F121-09/10

907.4, 907.4.1 (New) [IBC [F] 907.3, [F] 907.3.1 (New)]

Proposed Change as Submitted

TYPICAL FIRE-RATED STAIR PRESSURIZATION SYSTEM

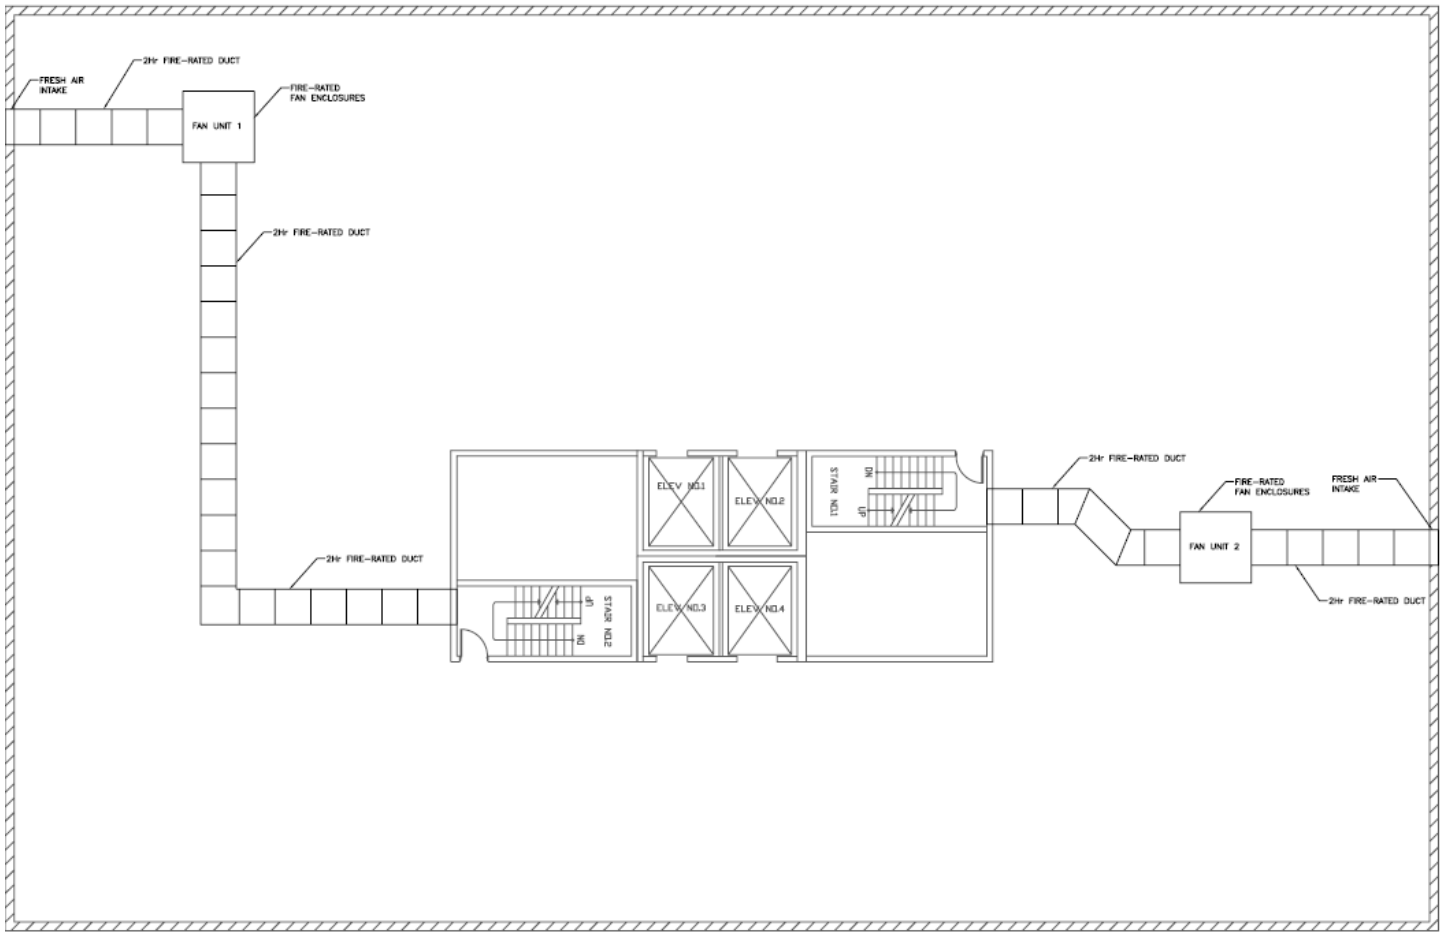
Commenter's Reason: The purpose of a closed pressurization system is to provide fresh air directly to stairwells or egress areas. This proposal would require Stair pressurization systems to be designed in accordance with the existing requirements of section 909, and require ducts installed for the purposes of stairwell pressurization to be enclosed within a shaft enclosure or alternate construction approved by the building official, in accordance with the IBC.

Where stair pressurization is used, the design air pressures need to be sufficient to maintain closed doors while preventing smoke from entering the egress path. At the same time, the ducts and fans supplying the pressurized air to the Stairwells need to be protected in order to ensure that they can continue to function in the event of a fire in the remainder of the floor area. This is particularly critical because, even if installed, fire and/or smoke dampers are not closed during a fire emergence in a pressurization duct designed to supply air to the stairwell.

The illustration below shows a typical contemporary floor plate. Stairwells are not typically located on the exterior wall of a building. It is not unlikely that the ducts supply the pressurization will pass through the floor area, and possibly through fire resistance rated separations. The IBC needs to stipulate the design and protection required to ensure reliable operation of these systems during a fire event. Properly designed stairwell pressurization prevents smoke from flowing back into the pressurized exit stairwells and smokeproof enclosures.

909.2 (IBC [F] 909.2) General design requirements. Buildings, structures or parts thereof required by this code to have a smoke control system or systems, or a stair pressurization system shall have such systems designed in accordance with the applicable requirements of Section 909 and the generally accepted and well-established principles of engineering relevant to the design. The construction documents shall include sufficient information and detail to adequately describe the elements of the design necessary for the proper implementation of the smoke control systems. These documents shall be accompanied by sufficient information and analysis to demonstrate compliance with these provisions.
